New BPW Shock Absorber Design

BPW Axles is introducing a new plastic protective tube design for its shock absorbers for series production as from week 29-2016.

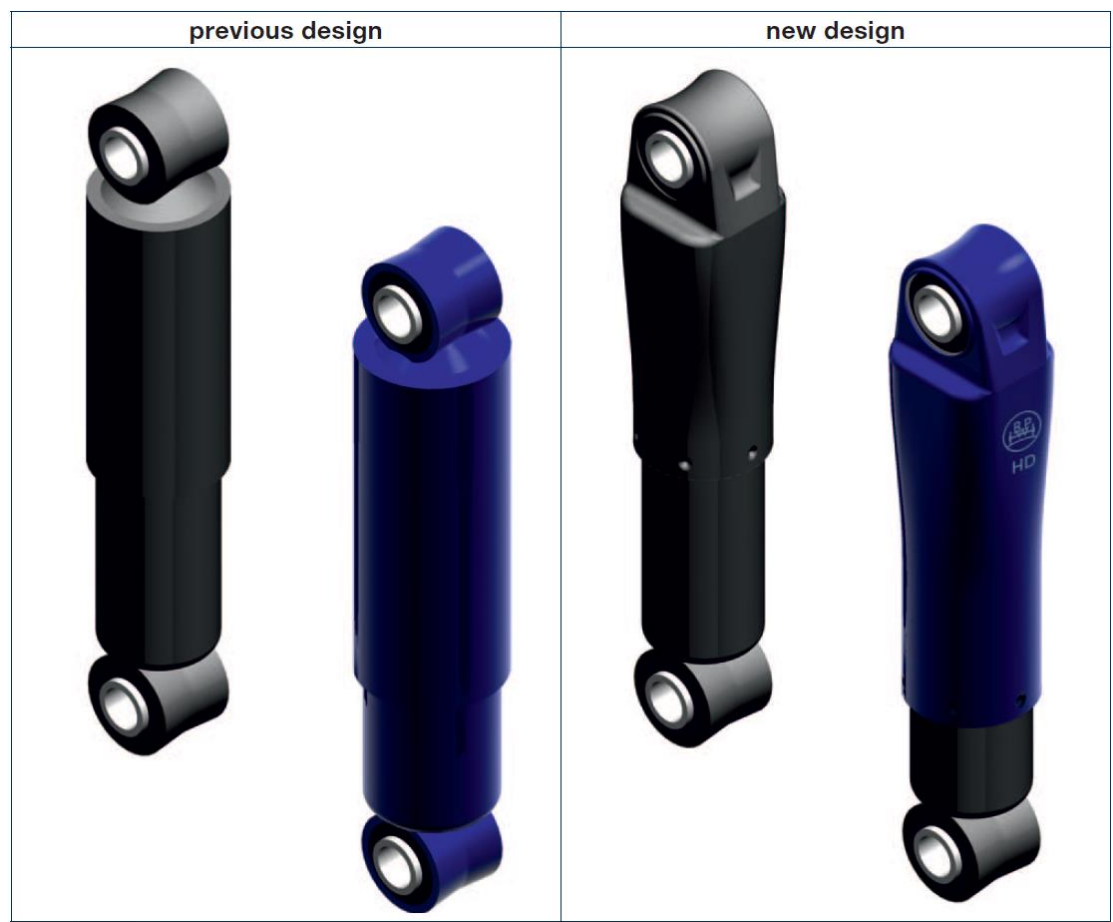
The shock absorbers are technically identical, right down to the design of the protective tube. This means that the shock absorbers are interchangeable and can be mixed in the same vehicle, or on the same axle.

Due to the protective tube being plastic, extra care has to be taken in the installation of the suspension into the chassis. It is important that the protective tube of the shock absorber has to be protected from welding splatter.

An example on how to protect the protective tube can be seen in the picture below. (Heat resistant cloth)
